07 May 2019

Camden Council Planning Department  
London Borough of Camden  
2nd Floor, 5 Pancras Square  
Kings Cross,  
London  
N1C 4AG

**39A Belsize Square - Summer House Modifications Planning REF:2018/0184/P  
Registered 15/03/2018**

Note: Photo of height dimension attached for information.

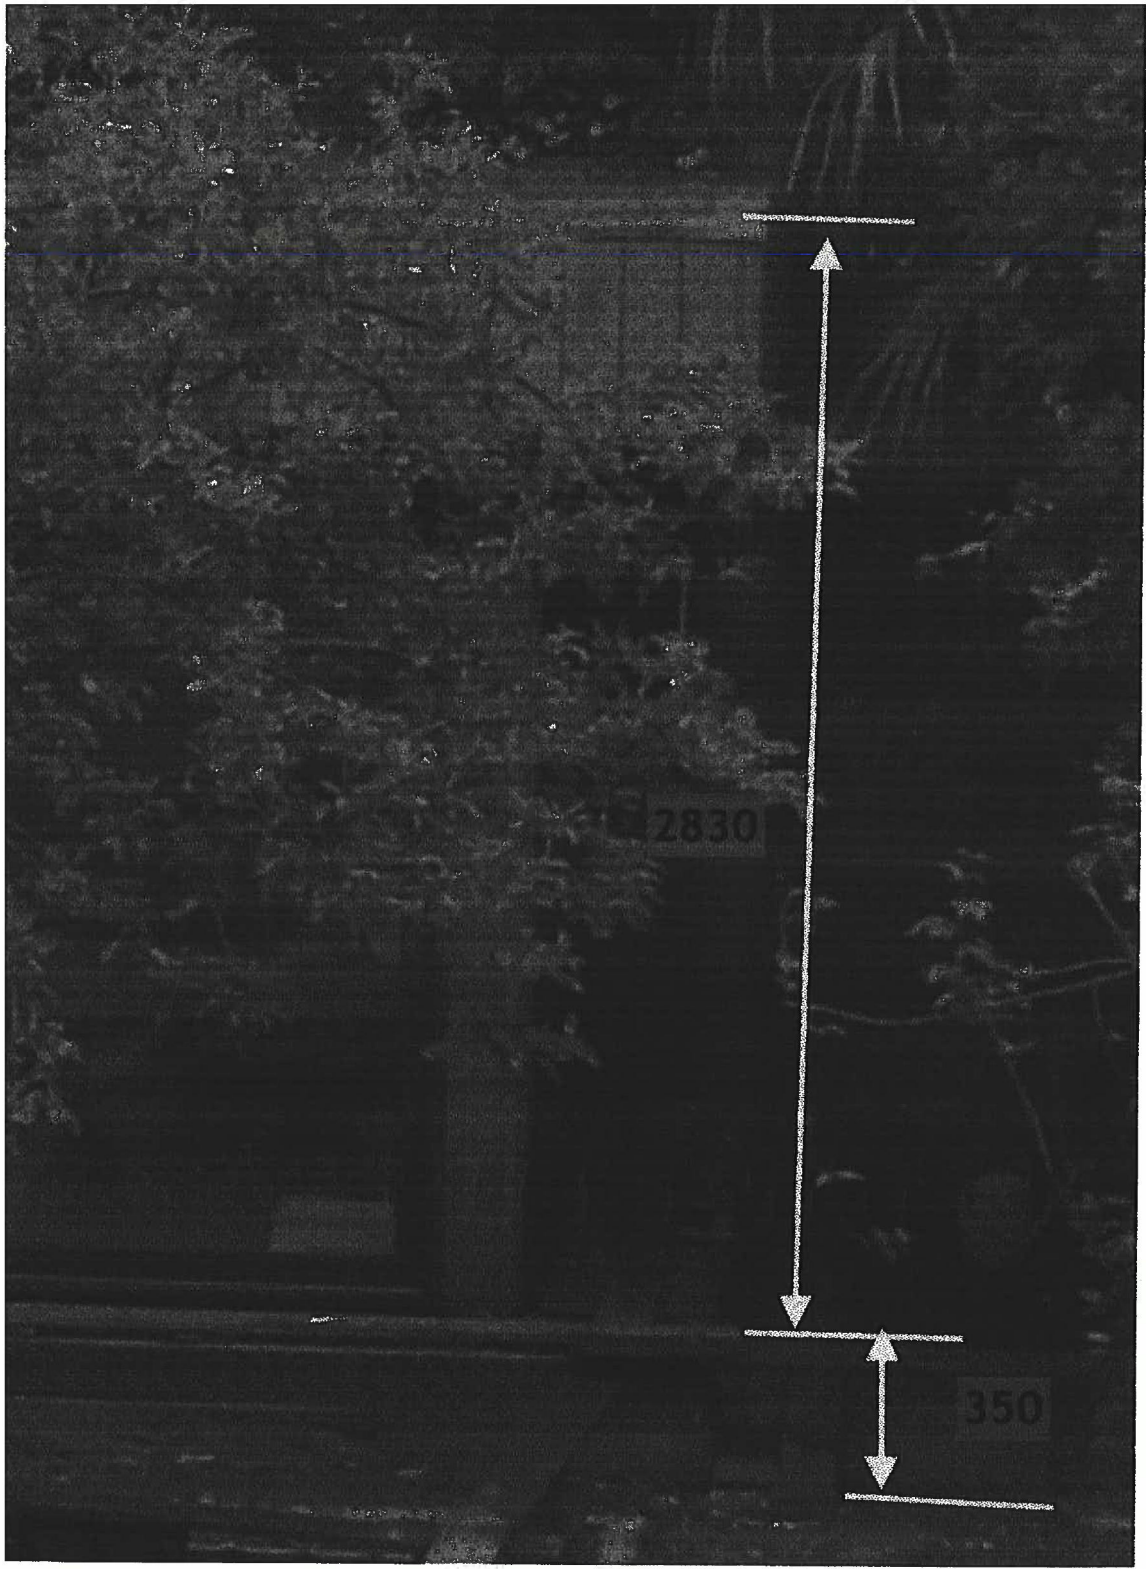
This then leads to what the actual height of the building is now. Accepting the measurement given by the applicant of 2830mm as the above deck height of the structure, you need to add to this the dimension the deck to ground floor level which is a dimension of approximately 300mm - which is a result of the summer house being constructed on a deep concrete raft. This gives an overall minimum dimension of  $2830+350 = 3180\text{mm}$ . **Which equates to a difference with the originally approved scheme of nearly 500mm.** It would be very difficult to see how this 'as built' height could be approved under an MMA, by the planning authority or in fact, at all. Half a meter higher than the original scheme and the expectation of the appeals officer that it was not to exceed 2.7m. in height.
